Manual: Owner's Manual P/N 6A8WWNM-2-20
(INSTALLATION MANUAL, MAINTENANCE MANUAL AND
ILLUSTRATED PARTS BREAKDOWN)

TR-2023-003: 29 August 2023

Owner's Manual
for IFEEL ENTERTAINMENT SYSTEM INSTALLATION
P/N 6AB1AD016-001

Appendix W to
6AB1WNM-2-20

Figure 6-9 Touch screen Retromod (31493)

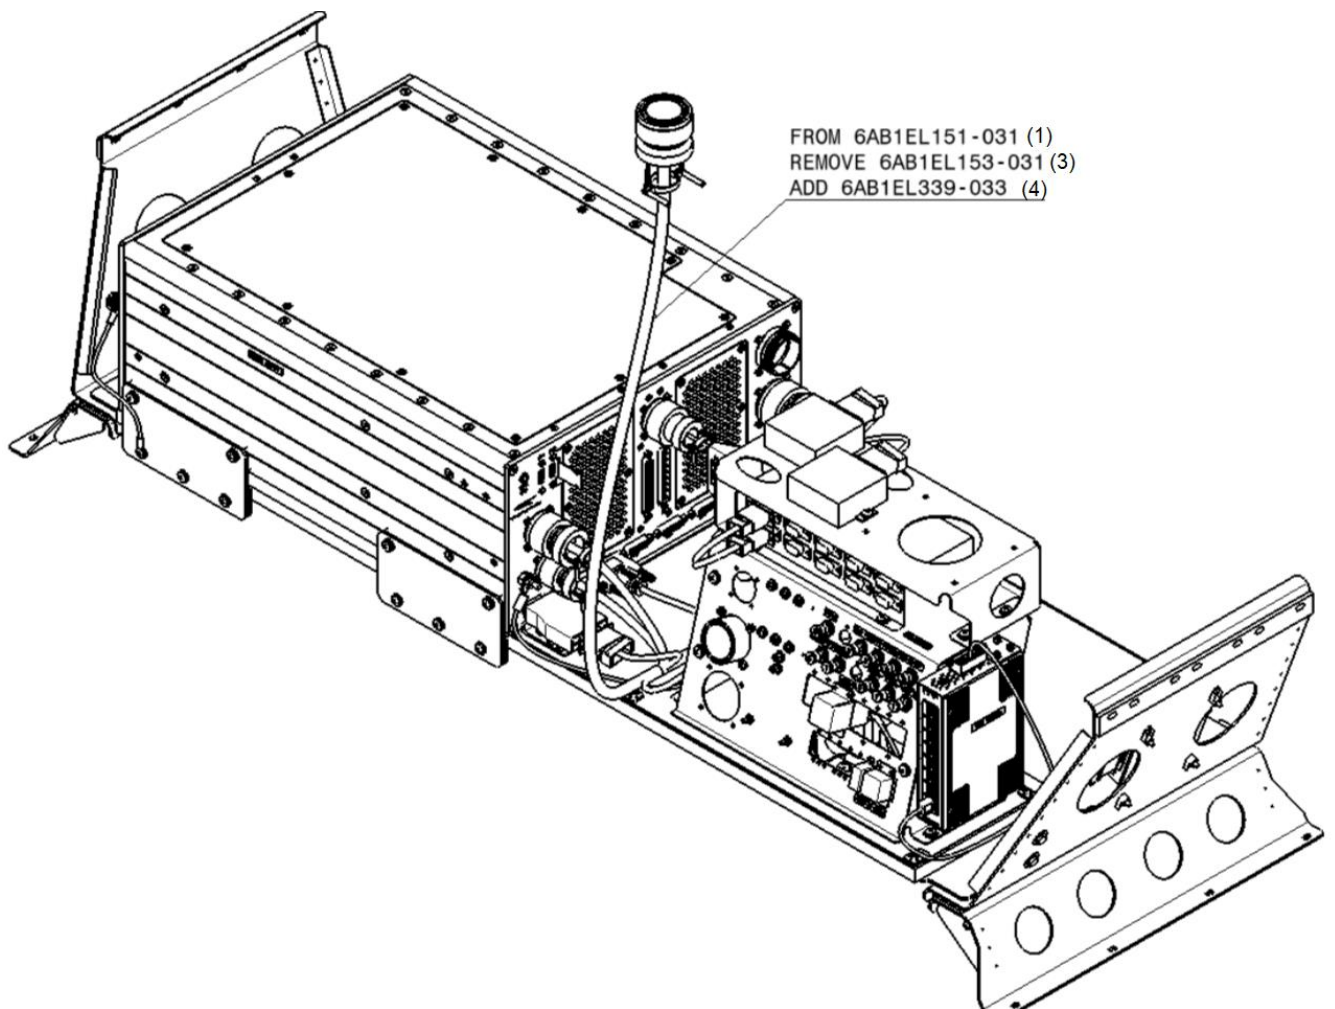
NOTE 5: The Touch screen retromod (31493) shall be installed only when touchscreen P/N 6IFCP001-242 or P/N 6IFCP001-243 or P/N 6IFCP001-244 or 6IFCP001-245 are replaced with touchscreen P/N 6IFCP-UNI-001
